# UNITED STATES PATENT AND TRADEMARK OFFICE

<b>Office Action Summary</b>	<b>Application No.</b> 10/517,845	<b>Applicant(s)</b> JONKKA, ARVO	
	<b>Examiner</b> Bena Miller	<b>Art Unit</b> 3725

## DETAILED ACTION

Figure 4 of Durkee

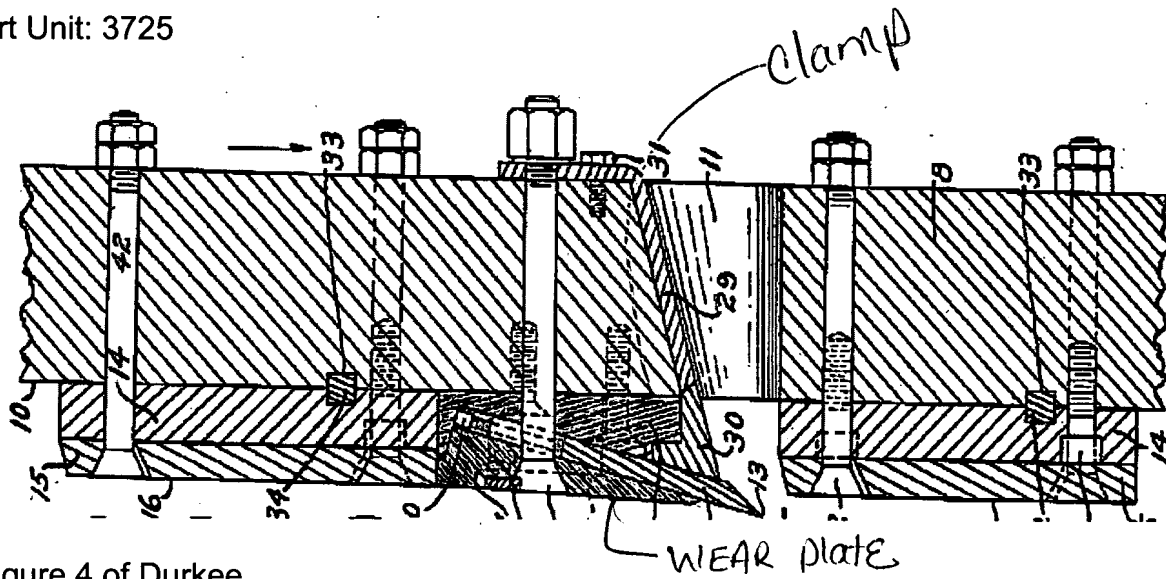
The device of either Durkee or Kershaw meets the limitation of both the method and clamping arrangement of the disclosed invention including the method of forcing (fig.4 or fig. 3, respectively), exerting (fig.4 or fig. 3, respectively) and a knife disc (fig. 3 or fig. 2, respectively); a wear plate (34 or 37, respectively) fastened on the knife side of the disc; a knife (12 or 33, respectively); a clamp (36 or see marked copy fig. 3, respectively); and compressing means exerting a force substantially parallel to an axis of the disc outward from the disc onto the clamp; wherein the knife abuts (note: knife 12 of Durkee abuts via 40) against a bracket of the clamp and the wear plate is provided with a matching groove for the bracket (fig. 4 or fig. 3, respectively), a projection, matching notch and matching groove (fig. 4 of Durkee). Applicants' attention is also directed to the marked copy of figure 4 of Durkee and figure 3 of Kershaw.
